# **Ecology – Proof of Evidence**

**Acting on behalf of Rushcliffe Borough Council**

Land West of Bradmore Road and North of Wysall Road,  
Land West of Wysall, Wysall  
Known as: Old Wood Energy Park

**Planning Inspectorate Reference: APP/P3040/W/25/3375110**

Figure 1 Skylark Mitigation Suitability Plan

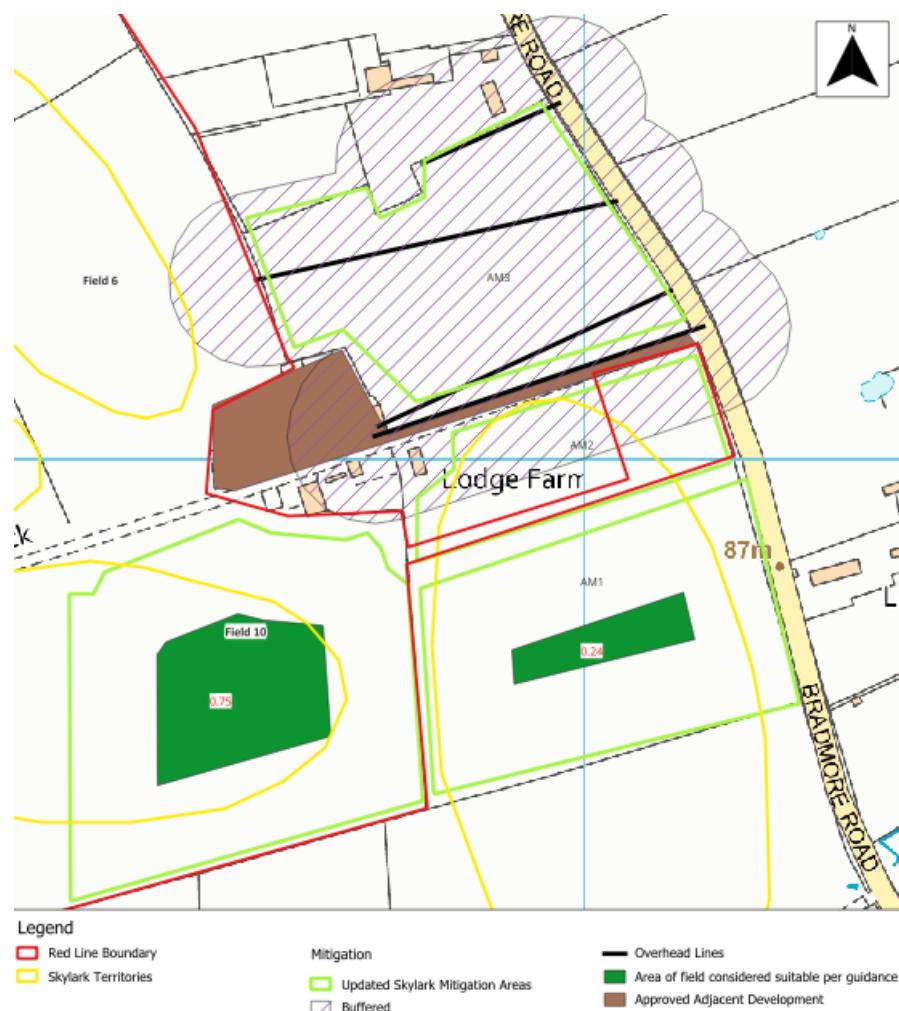
- 3.6.2 In simple terms, the area of habitat to be lost is c.95ha (para 3.5.60 of EclA CD 3.8 and agreed in the SoCG) with the proposed original mitigation providing approx. 3.62ha, reduced to <1ha with appropriate buffers from limiting factors such as trees, buildings and field boundaries as per best practice guidance (see Appendix 1 Mitigation Drawing).

3.7.1 The additional fields (labelled AM1/2/3 on our plan(s) for reference) proposed with the Appeal provide limited suitable habitat for breeding skylark due to their size and presence of buildings, overhead cables and tall vegetation to field boundaries (see Appendices 1 and 2).

- Additional Mitigation Field 3 (AM3) – <5ha with structures and trees/vegetation around the boundaries. The whole field is made unsuitable by the presence of multiple overhead cables (Figure 1 above, see Appendix 1 Mitigation Drawing for full scale plan). It is also clear from the baseline surveys in 2022 that no territories are present within this field, this indicates a reluctance to use this field for nesting given territories present wholly or partially within all other fields both on this site and the adjacent scheme. Skylark were observed in all fields during the surveys for this site and the adjacent site with this field being the exception where no skylark were observed.
